MODIFICATION RECOMMENDED

DSOX2014A-03

S E R V I C E N O T E

DSOX2014A – Oscilloscope, Mixed Signal, 4 Channel,
100MHz

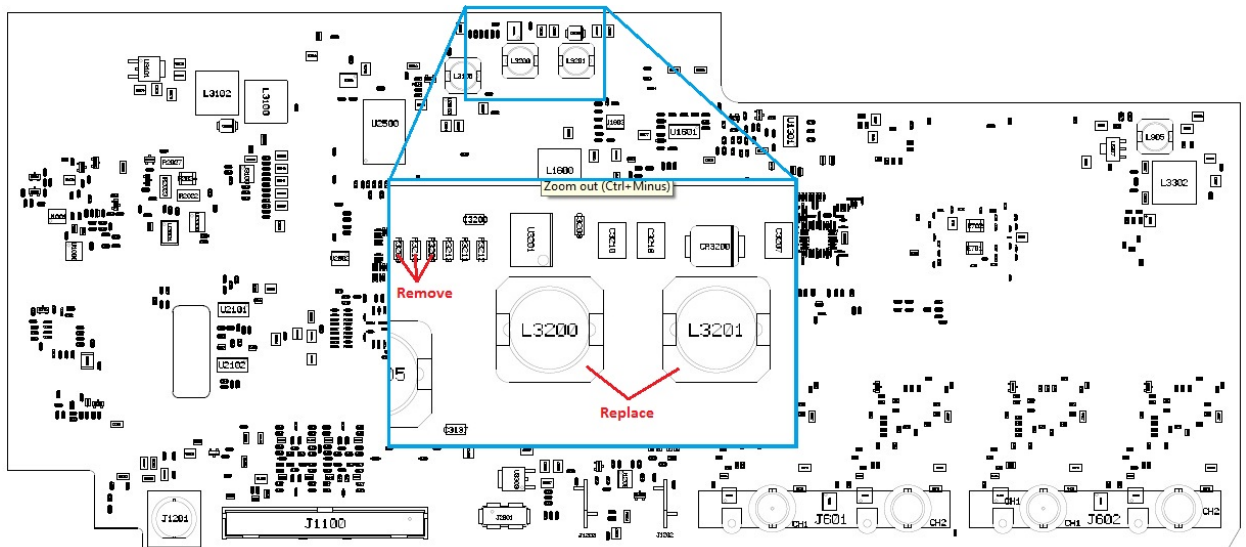
1. Follow the procedure to remove the acquisition board for the X2000 as in the Agilent 2000/3000 X-Series Oscilloscopes Service Guide (<http://cp.literature.agilent.com/litweb/pdf/75019-97039.pdf>), pp. 117-121, until you make a visual to the following components:

2. As the picture indicates, remove the three resistors (0699-7209, 1 Ohm) located at R3208, R3209, and R3210. They are not to be replaced.
3. Remove as well the two inductors (9140-6474, 100uH) located at L3200 and L3201 and replace them with inductors with part number 9140-6151 (68 uH).
4. Re-assemble to the point where the unit could be powered up to verify that the hissing is indeed gone. If the hissing is not gone, please, check modifications.
5. When the hissing is gone, put oscilloscope back together.
